GTS Newsletter

2009/05E

Machine	TASKI swingo XP
Subassembly	Base

Ball Joint / Flat Spring of Squeegee Lowering Mechanism

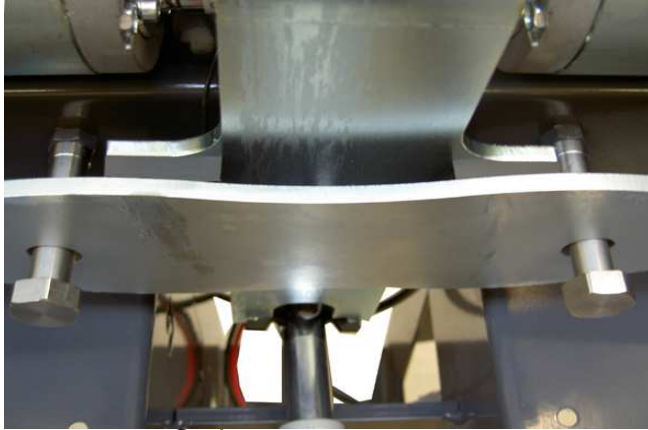
We have recognised that in case the squeegee collides heavy with an obstacle during reversing it might happen that the swinging arm can come off its bracket. This could lead to damages of the traction motor as well as of the brake cables.

To avoid such damages the ball joint has been modified and the tolerance of the flat spring has been reduced. With these adjustments it is no longer possible that the swinging arm can pop out of the bracket.

Deepness of ball joint bracket increased to app. 10mm

Bolts will be used as distance pieces

To the flat spring 2 holes have been added (holes are not centered)

View of the complete modification

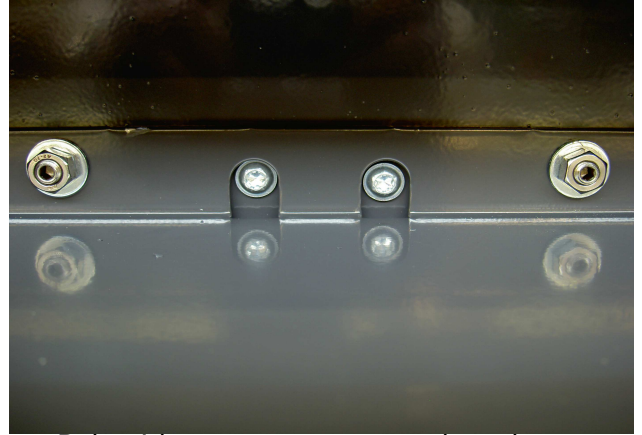
Spring compartment

Bolt with counternut at step board

- Remove the 2 centred screws of the step board fixation
- Get access to the flat spring compartment
- Remove current/old flat spring
- Position new flat spring with holes (Attention: holes are not centred)
- Mount the 2 limitation bolts
- Refasten new flat spring
- Mount counternut and washer onto the bolts to fixate the step board
